July 30, 2020  
File No. 2020-034A

Re: Site Plan Comments  
Proposed Comet, LLC Commercial Development  
Tax Map 34, Lots 4-1 & 4-2  
9 Route 103 West  
Warner, New Hampshire

SITE PLAN REVIEW  
PROPOSED COMET LLC COMMERCIAL DEVELOPMENT  
9 ROUTE 103 WEST  
WARNER, NEW HAMPSHIRE

FIGURE 1

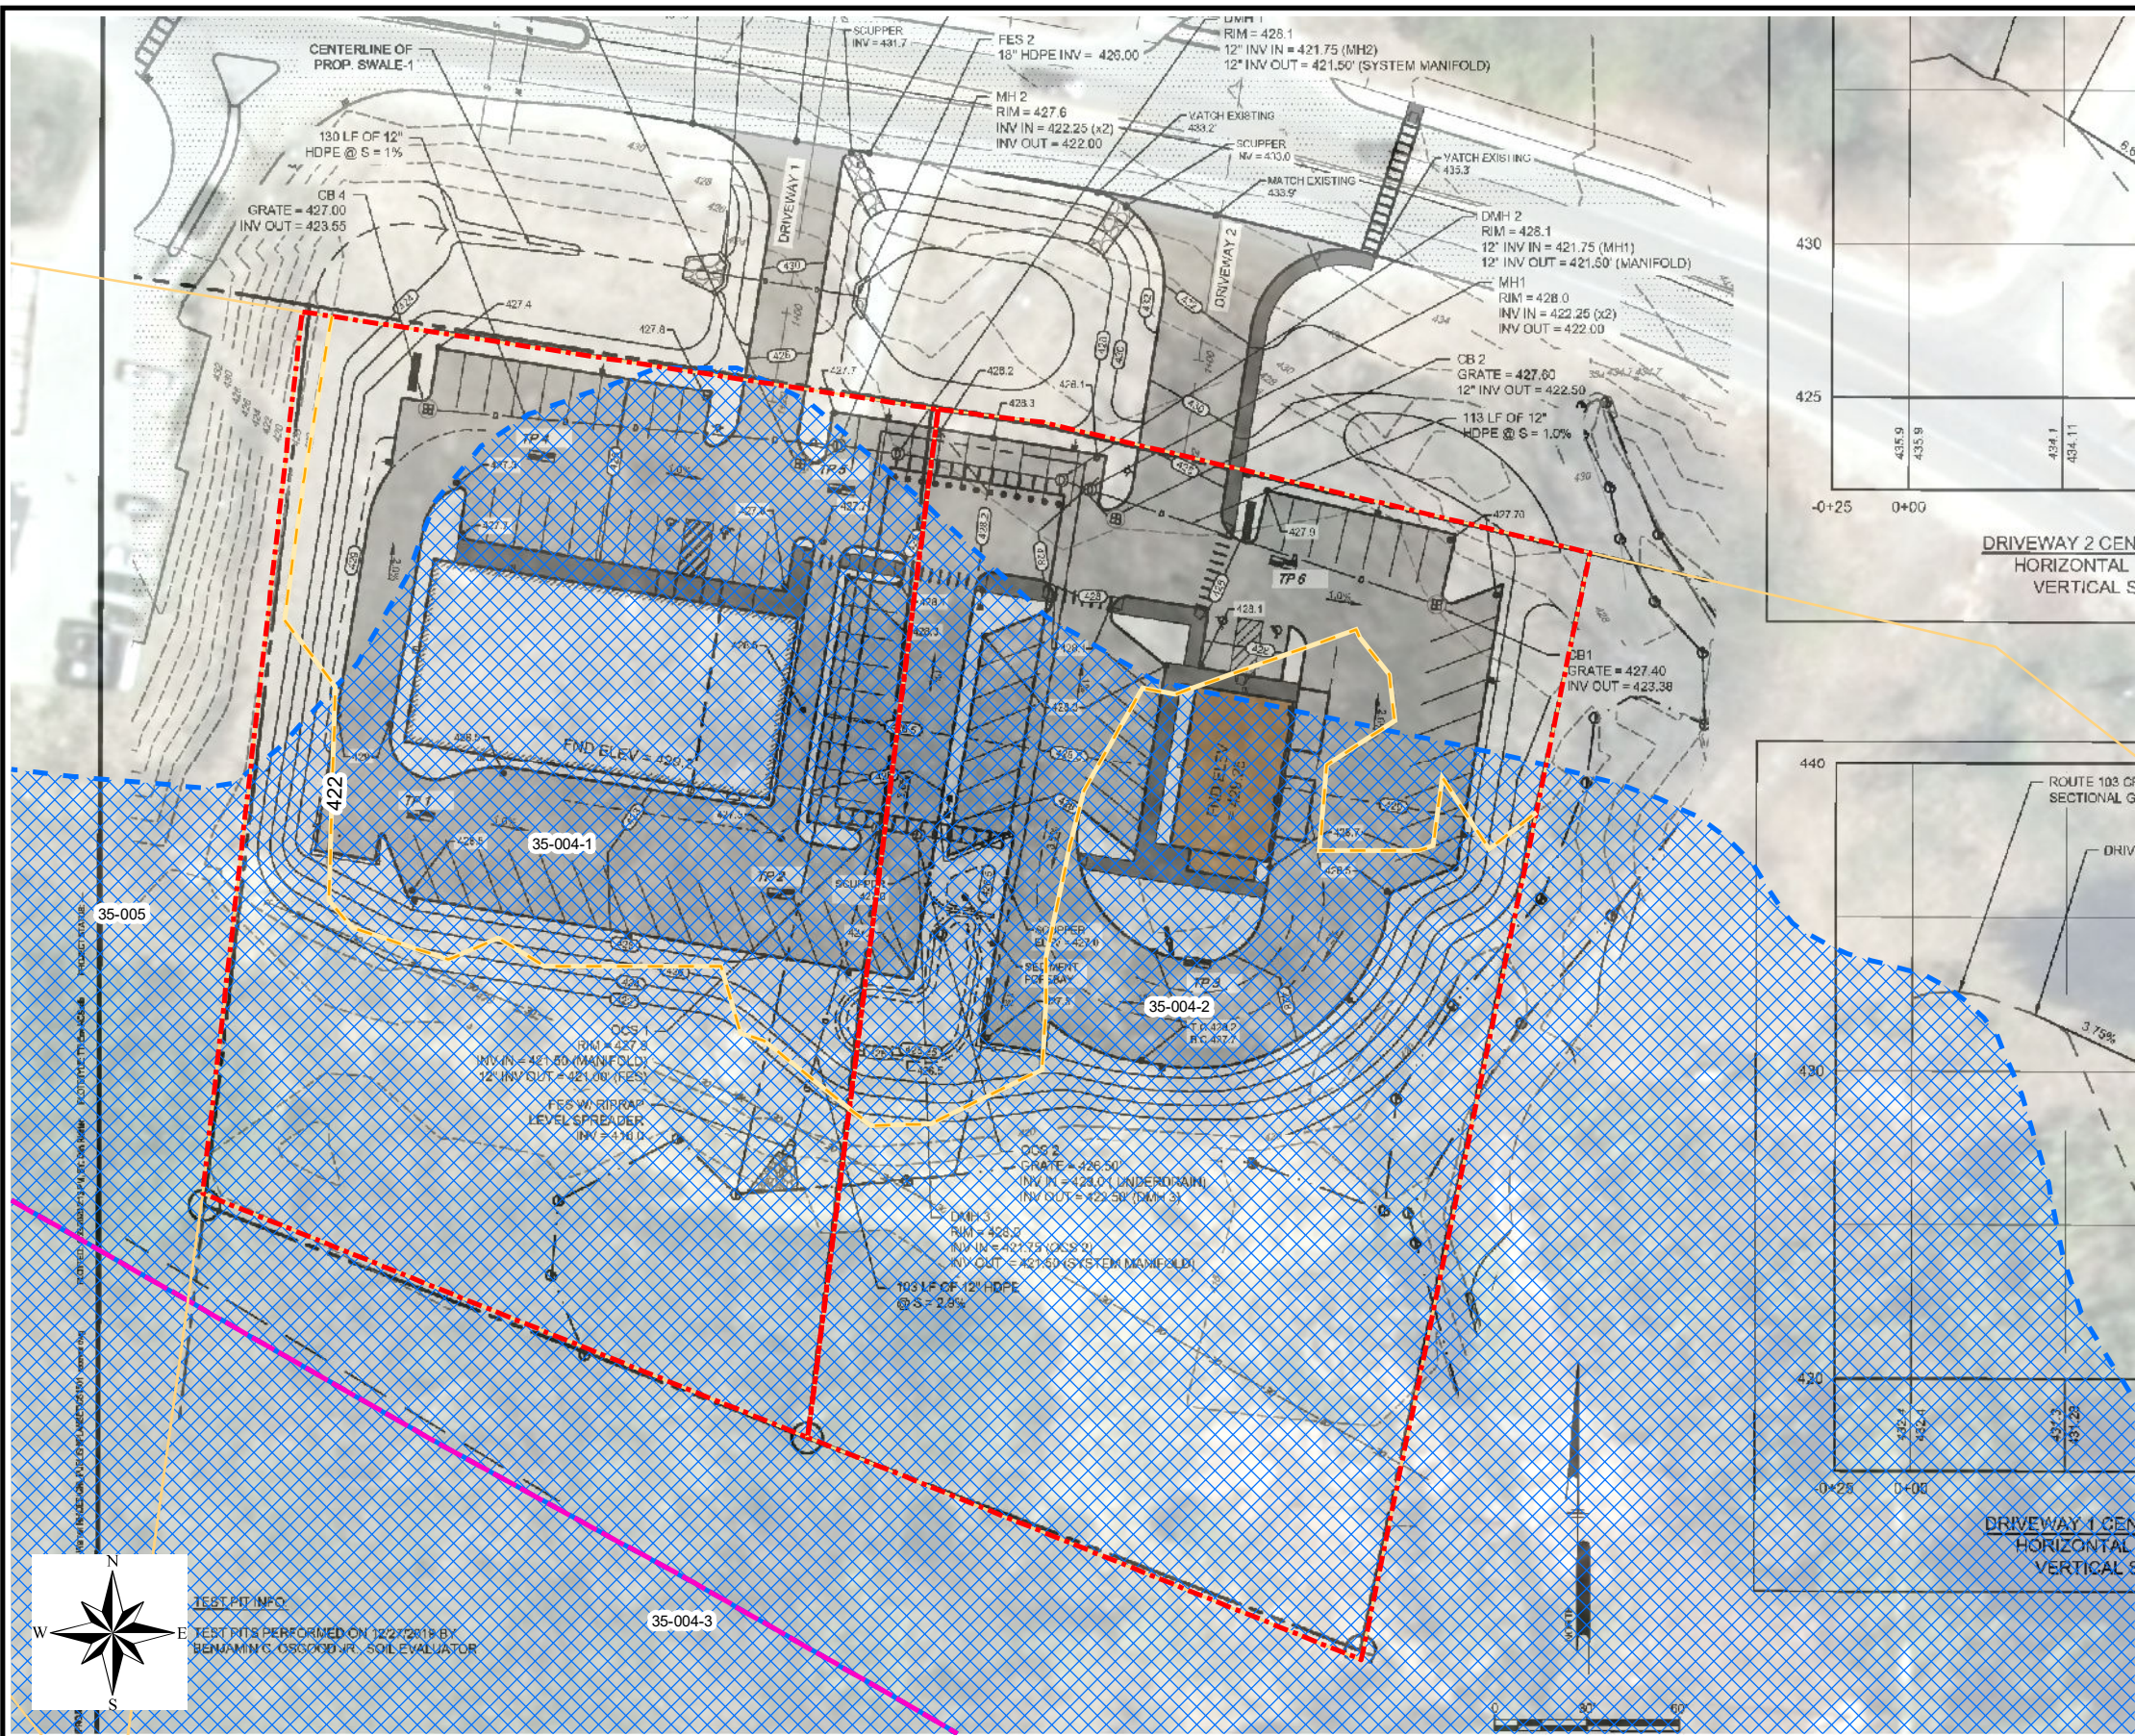
4. Aries notes that Ranger's 100-year floodplain extent does not match the 100-year floodplain extent depicted in Federal Emergency Management Agency (FEMA) *Digital Flood Insurance Rate Map (DFIRM) Database for Merrimack County, NH, USA*, dated April 19, 2010. Attached Figure 1 depicts the 100-year Flood Zone AE, which extends into the proposed development area. Available GIS data

provided with the DFIRM indicate that a base flood elevation contour of 421 feet is present approximately 1,200 feet downriver of the proposed site development area extent. As such, Aries infers that a base flood elevation (BFE) at the site is greater than the BFE contour of 421 feet used by Ranger, but less than an elevation of 422 feet. Ranger's ground surface contours indicate that a significant portion of the proposed site development area on Lot 4-2 is below the 422-foot elevation contour. Aries recommends that Ranger demonstrate that placement of approximately seven feet of fill on the site parcels will not impact floodwater storage.
